**SONGS-1 Long Term Service Seismic
Reevaluation Program**

**Status Report for all Action Items
Identified from the NRC Letter
dated March 27, 1985**

SOUTHERN CALIFORNIA EDISON

May 31, 1985

Figure 1: Secant Stiffness Method Flowchart

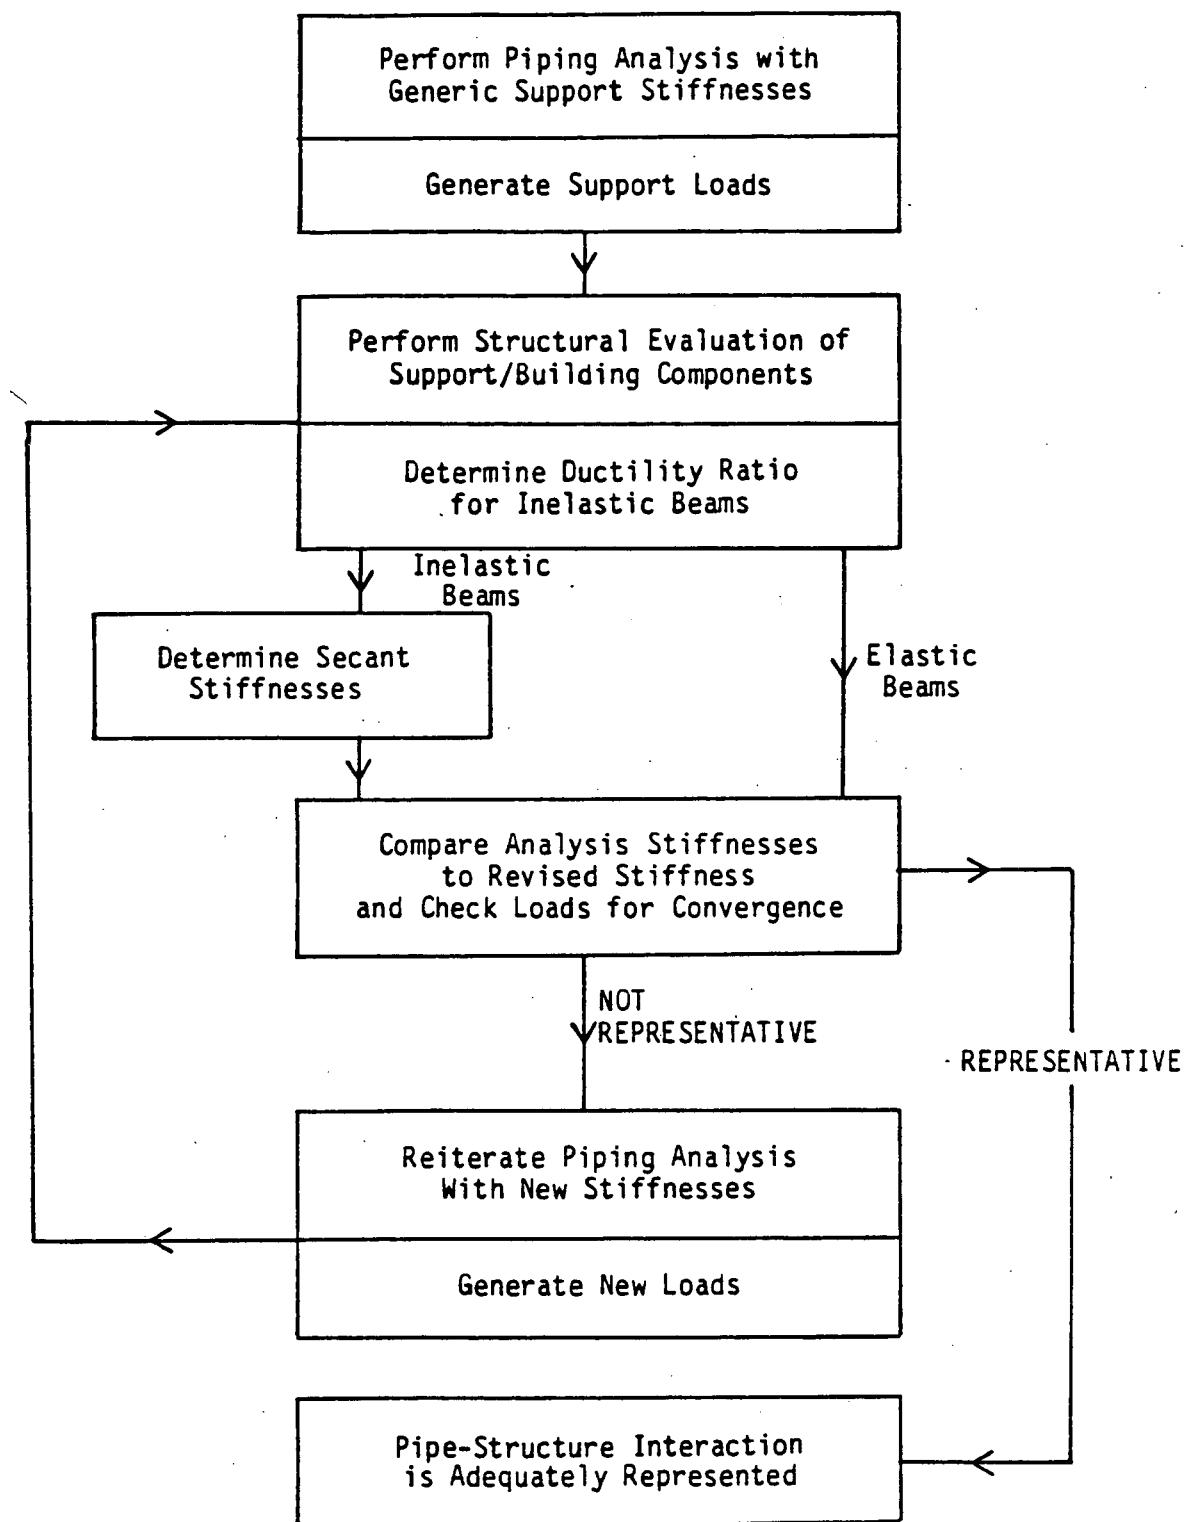
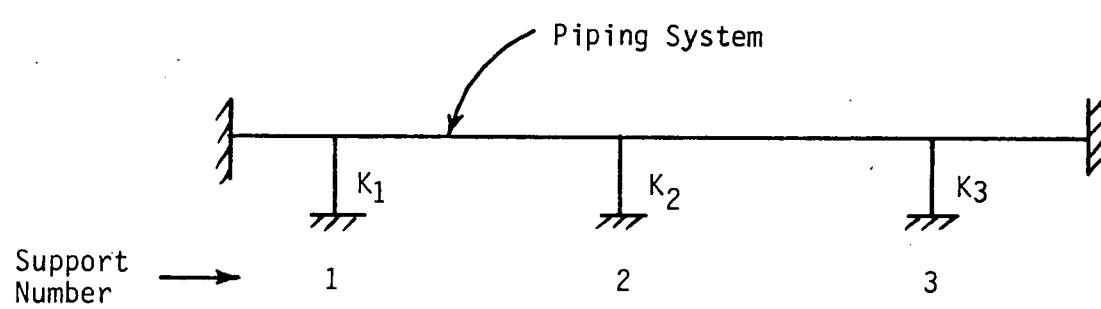
The secant stiffness method has not been presented in sufficient detail for the staff to review. (LTS Section 4.2.2.3)

A report summarizing the secant stiffness method as will be applied for SONGS-1 LTS was submitted to the NRC on April 15, 1985. At the May 1, 1985 meeting, the NRC requested additional information to describe the situations in which the secant stiffness method will be used for LTS, particularly the distinction between the secant stiffness application and the Energy Balance Method application. The following is a response to these questions:

The iterative procedure for the secant stiffness method is outlined in the flow chart shown in Figure 1. To explain this procedure, the analysis steps will be illustrated through a simple example problem. Figure 2 shows a straight span beam which represents a piping system. The system is supported by three supporting elements.

The initial analysis of this system (iteration 1) is performed with generic support stiffness values as shown in Table 1. The support loads (P_{11} , P_{21} , P_{31}) obtained from this analysis are then applied to the supporting structure (which is comprised of the pipe support and the secondary steel member). In this example, support numbers 1 and 3 remain elastic (ductility less than one), whereas support number 2 exhibits inelastic behavior (ductility of 2.0). This ductility value is now used to estimate the revised stiffness:

This revised stiffness of the inelastic support (K_{22}) is now used in iteration 2 of the piping analysis to develop revised loads (P_{12} , P_{22} , P_{32}). The support loads and stiffness for iteration 1 and 2 are compared and are seen to be significantly different. This indicates that convergence of results is not yet achieved. The revised loads are used to evaluate revised ductilities and, subsequently, revised stiffness for the inelastic support (K_{23}).

Iteration 3 is performed with the revised stiffness K_{23} . The loads and stiffnesses are then compared for iteration 2 and 3. The support loads for iteration 3 remain basically unchanged (difference from previous iteration less than 10 percent on the average), demonstrating that support loads have converged to the iteration 3 stiffness values. Thus, pipe-structure interaction is accurately represented.
